MARICOPA COUNTY
Department of Transportation

MEMORANDUM

Date: January 8, 2016
To: MAG Specifications and Details Committee
From: Robert Herz, MCDOT Representative
Subject: Miscellaneous Corrections **Case 16-01A**

PURPOSE: Delete extraneous text.

**ENCASED CONCRETE PIPE
(FOR SHALLOW INSTALLATION)**

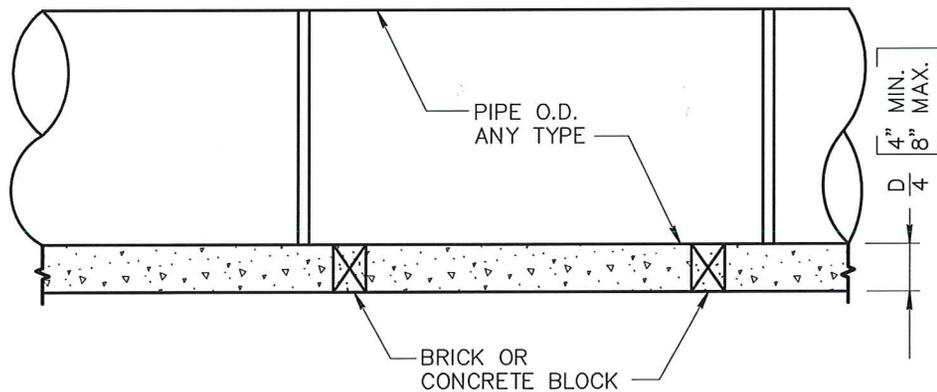
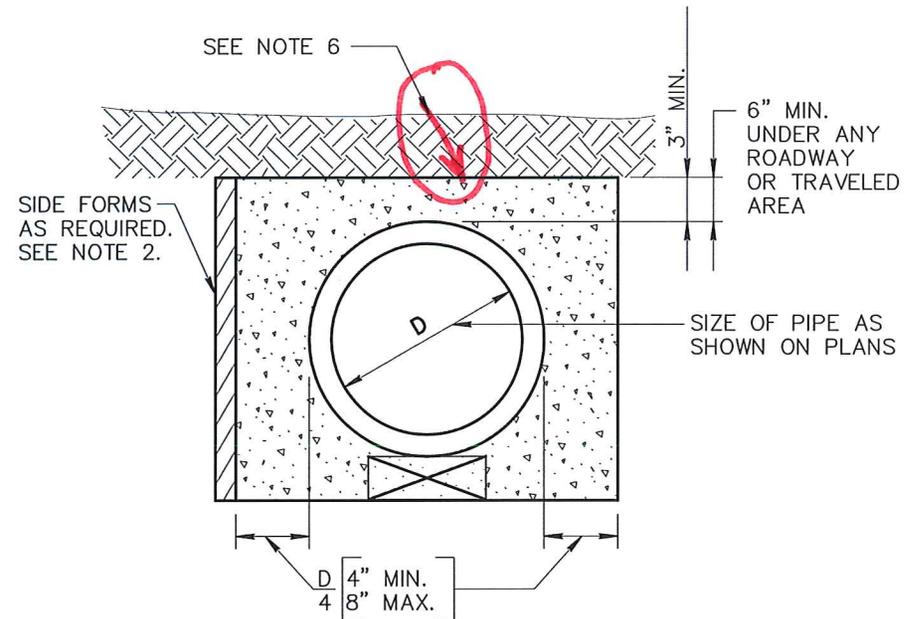
CASE 16-01 B
